RE: the 900 New Hampshire project.

Please consider this addendum to my letter of 4 April regarding the request by Treanor Architects that you overturn historic resource findings regarding 900 New Hampshire Street.

RE: 900 New Hampshire Appeal from HRC,
Case # DR-12-185-11

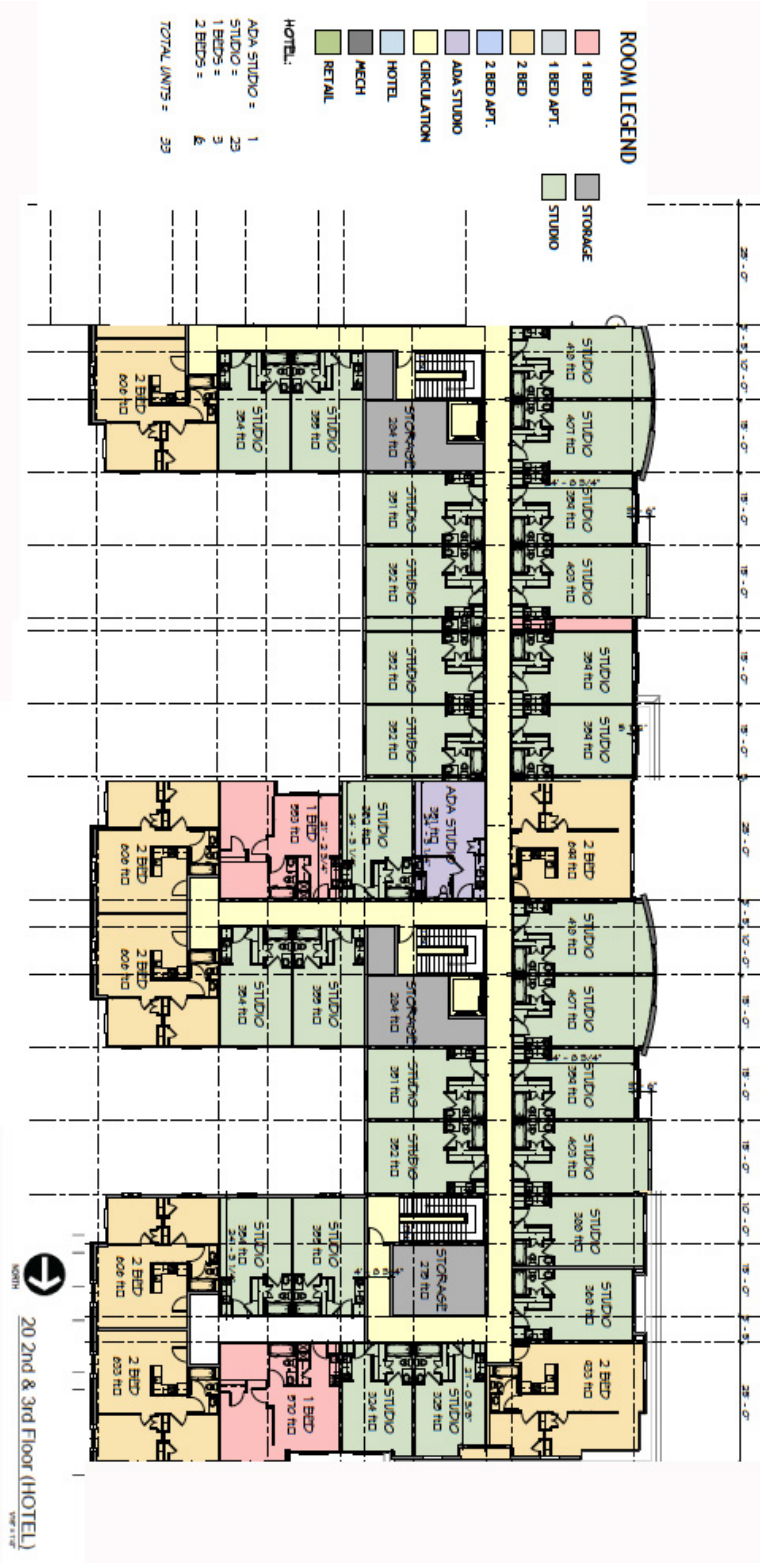
Rooftop structures of Treanor design are redundant and can be eliminated. Eliminating redundant elements decreases height, as required by HRC, and eliminates need for public subsidies.

True scale view of new three-story design alternative presented in this document. Eliminating unnecessary rooftop structures, unfeasible retail space, reclaiming space wasted by courtyard and filling the lot makes a structure in harmony with the district.

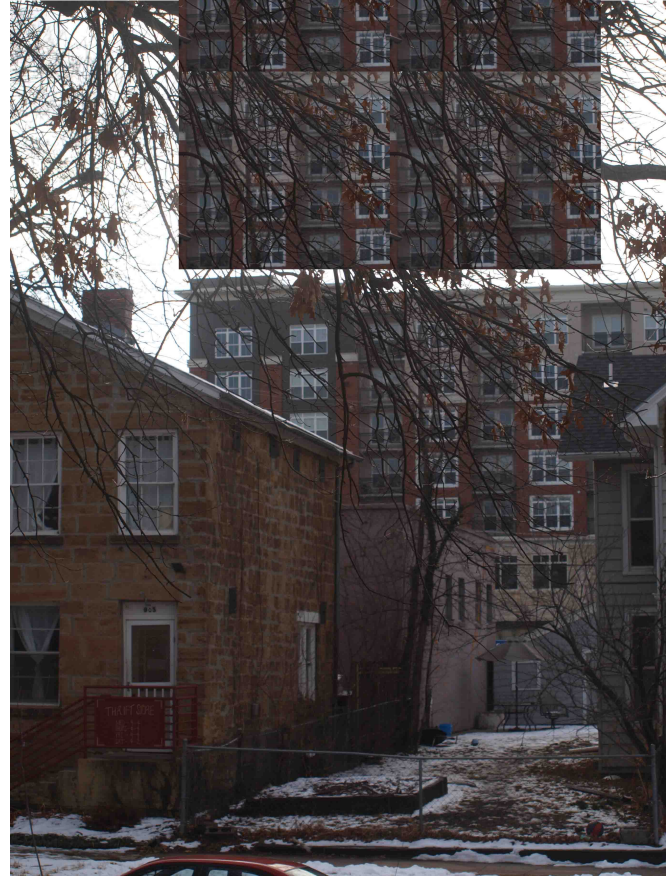
Every issue in my previous letters of December 11 and December 14 remain valid and current. This letter will limit discussion to deceptive renderings of overall height. In a presentation to neighbors at the Library on February 1, Treanor showed “exact scale views” of the proposed project as seen from Rhode Island Street. These views showed the new project as visible *well below the sight lines of rooftops*. The views were challenged by pointing out that 901 New Hampshire already *looms high above the Historic District rooftops* while being hundreds of feet further away.

It is simple to extend one of Treanor’s sight lines (red) to show that proposed structure looms half again or more above the bulk of 901 NH. Its roof is 70 feet above ground level on the south end: a 6-story insult that includes an offensive glass ornament made with total disregard for historic context and Department of Interior guidelines. If built the structure will block the sky like a 20- story building downtown: while being 15 feet from the historic properties.
